The Priory Development Assessment

Sydney North Planning Panel

Panel Reference															
DA Number	2021/1257														
Local Government Area	Hunters Hill														
Proposed Development	Adaptive re-use of ‘The Priory and Curtilage’ involving conservation works and alterations and additions to facilitate a change of use to a Restaurant and Café (total seating for 416 patrons). Works include the reconfiguration and extension of the existing carpark, access, and landscaping works.														
Street Address	10-14 Salter Street, Hunters Hill														
Applicant	Priory Settlement PTY LTD														
Owners

Lot Number	Street Address	Owner	Lot 1 of DP 823988 The Priory	10-12 Salter Street	The State of NSW (Crown Land)	Lot 3 of DP 1128452 Riverglade Reserve	14 Salter Street	Hunter’s Hill Council	Lot 4 of DP 1128452 Riverglade Reserve	14 Salter Street	Hunter’s Hill Council
Lot Number	Street Address	Owner													
Lot 1 of DP 823988 The Priory	10-12 Salter Street	The State of NSW (Crown Land)													
Lot 3 of DP 1128452 Riverglade Reserve	14 Salter Street	Hunter’s Hill Council													
Lot 4 of DP 1128452 Riverglade Reserve	14 Salter Street	Hunter’s Hill Co

Figure 5: Extract from CMP 2021 showing stages in the development of ‘The Priory’ and the significance level of the buildings.

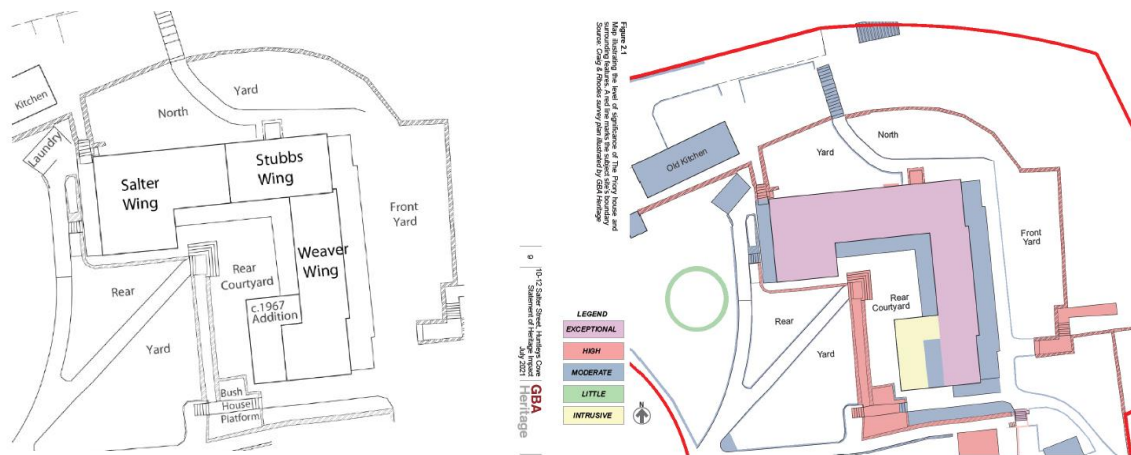
1. The proposed modification of the hip roof of the original southern pavilion of the Weaver Wing (c1857) and the demolition of the remains of the boiler house graded exceptional significance. The replacement roof was completed in 2011 as part of the NSW Heritage Grant Program (CMP, p48).

2. The proposed demolition of the verandah to Salter and Weaver Wing, graded moderate significance, which are typical of the period and function of building as indicated on the Historic Phase House Plans (CMP, Appendix 3) and replacement by skylights.

1. *The old kitchen is described in the CMP as the 'Stubb's era kitchen' (CMP, p31) and is evident on the 1885 Crown plan showing the Priory property (CMP, p26). While it may have been subject to modifications, the building that could be one of the earliest on the site, contributes to the variety of buildings that make up the item and therefore its moderate grading is questioned. For these reasons, the proposed scale of the café extension, including its proximity to the entrance driveway, the severing of its important connection to the Salter Wing, the proposed opening of its northern wall and lowering of the floor level, severely diminishes the ability to interpret this building and its relationship with the main house.*

Figure 6: Extract from HHLEP 2012 zoning map. It shows the zoning of the three lots (Lot 1, 3 & 4) subject of the DA.

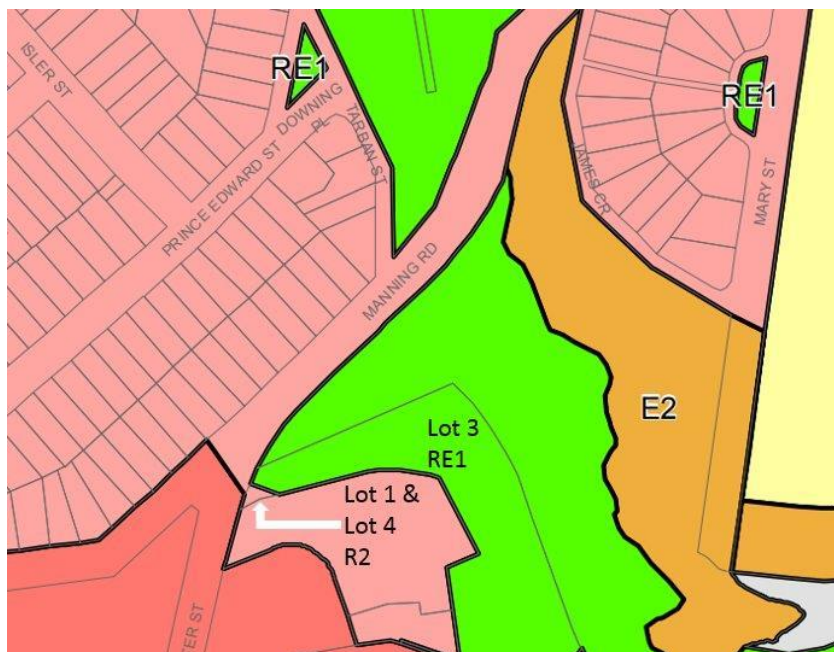
Lot Number & Ownership	Zoning	Work proposed	Permissibility of Land Use
			<p><i>Community facilities; Dual occupancies; Dwelling houses; Group homes; Home-based child care; Oyster aquaculture; Places of public worship; Pond-based aquaculture; Respite day care centres; Secondary dwellings; Tank-based aquaculture</i></p> <p>Comment: A car park is not a permissible use within an R2 zone and therefore the proposed works in Lot 4 including the widening of the vehicular entrance to the site to allow two-way access into the carpark is not permitted development.</p>

- 1.2. Pursuant to Section 4.15 (1)(a) of the Environmental Planning & Assessment Act 1979, the proposed development contravenes the provisions of the Hunters Hill Local Environmental Plan 2012 as the works on Lot 4 DP 1128452 are prohibited under the applicable zoning (R2 Low Density Residential).

Figure 9: Level of significance of existing planting around The Priory.

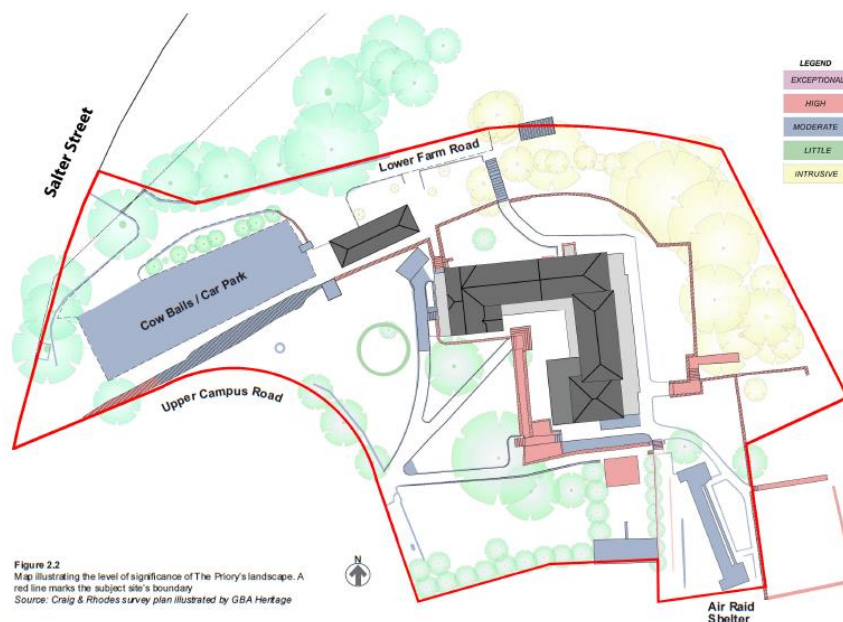
These above extract and diagram from the CMP and HIS provide context to the proposed removal of 13 trees to the east of The Priory and why their removal will not negatively impact heritage significance, but rather help enhance The Priory's setting.

However, this not the case with the trees proposed to be removed to facilitate the extension of the carpark and cafe. A 1943 aerial photo of the site included on page 37 of the CMP 2021 shows a number of mature trees lining the driveway to the site. This indicates these trees may have been planted prior to WWII and therefore the loss of their contribution to the historic setting of The Priory needs to be addressed in the SHI. Particularly, as the removal of these trees will alter the currently 'green entrance' to the site and the enlarged carpark will increase the hard surfaces around The Priory.

The proposed carparking in close proximity to the site entry (spaces 25-31) including removal of existing mature Camphor Laurels does not allow for replanting at the site entry and is not supported. A row of these trees is evident along the driveway on the 1945 aerial.

The expanded carpark design alone results in the removal of 10 healthy trees at the Salter Street entrance and the design of the carpark appears to precludes the ability to provide significant replacement planting to soften the increase in hard surfaces. As the trees to be removed may pre-date 1943 the impact of their removal on heritage significance is required.
